# Capture additional DER information

DRS Meeting  
July 16, 2018

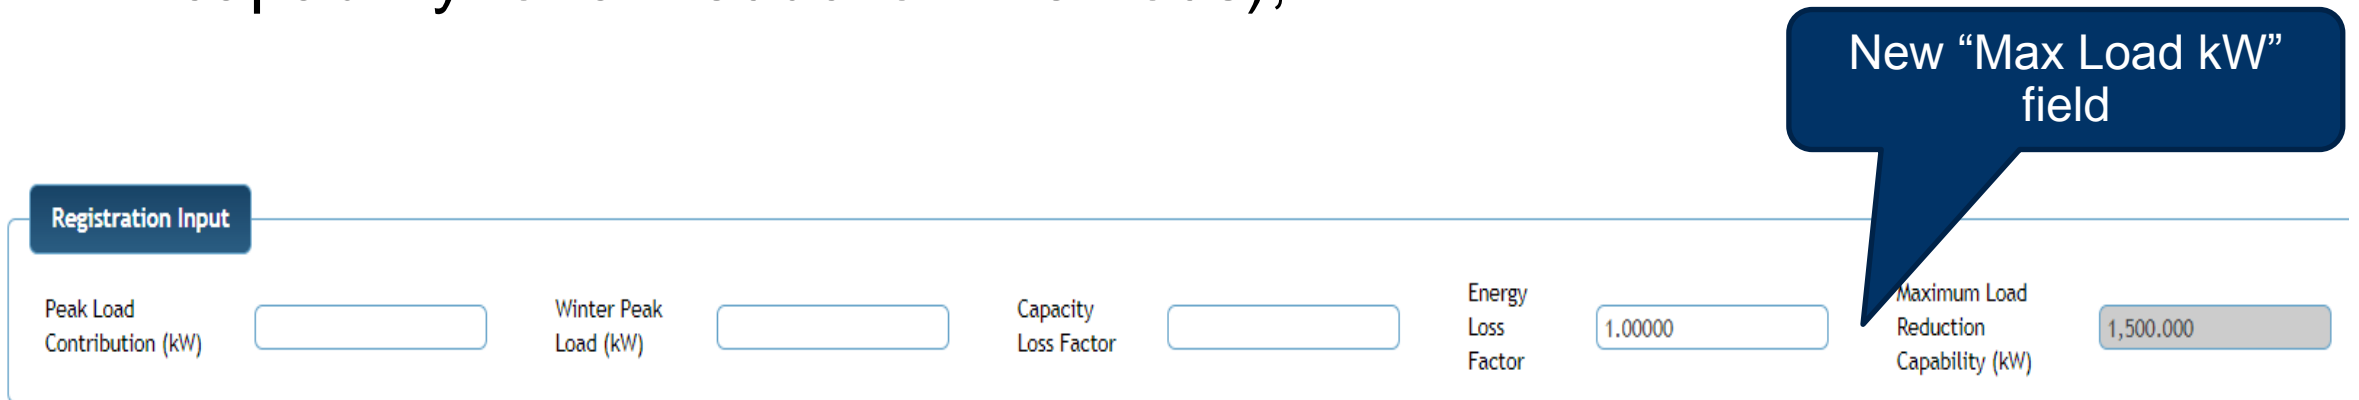
- Create a new Battery Section with attributes similar to generator section
- New fields in battery attributes section:
  - Max Output (kW) - this field rolls up to Batteries (kW) in the Load Reduction Method section;
  - Battery Capacity (kW 1C) - a 1C rate means that the discharge current will discharge the entire battery in 1 hour;
  - Vintage - the year the battery was manufactured;
  - Chemistry: Lithium-Ion, Lithium-Air, Lithium-Metal, Lithium-Sulfur, Lead Acid, Zinc-Ion, Sodium-Ion, Sodium-Metal Halide, Magnesium-Ion, Magnesium-Lithium Hybrid, Zinc-Manganese Oxide, Vanadium-Redox Flow, Zinc-Polyiodide Flow, Organic Aqueous Flow;
  - Type: Electric Vehicle, PV system, stand alone;
  - Note

- Max Output field will capture battery/generator kW capacity for DR.
- Generator Max Output kW should be  $\leq$  Nameplate kW;
- Battery total Max Output kW should be  $\leq$  Battery Capacity kW;
- If there are other load reduction methods used at the location in addition to generator or battery then generator/battery Max Output field should reflect the expected load after the other load reduction methods;
- Example:
